REMARKS

THE DIRECTV GROUP, INC.
(formerly Hughes Electronics Corporation)
Customer No. 20991

IN THE DRAWINGS

FIG. 11

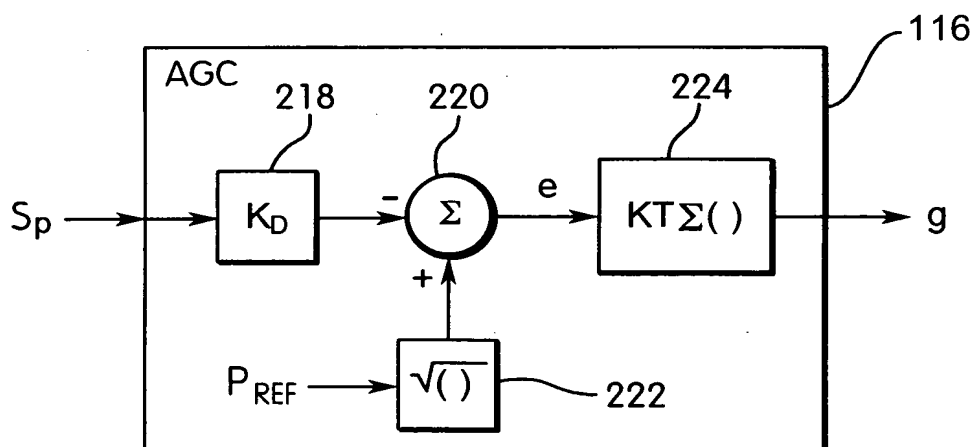
The Office Action (§ 7) objects to Figure 11, because the AGC Block Diagram is numbered as item 112, and should be numbered as item 116. In response, Applicants have hereby amended Figure 11 to change the numbering for the AGC Block Diagram to item 116.

Please replace the drawing sheet with Figures 9, 10 and 11 with the attached replacement sheet for these figures, in which the AGC Block Diagram of Figure 11 has been renumbered as element "116".
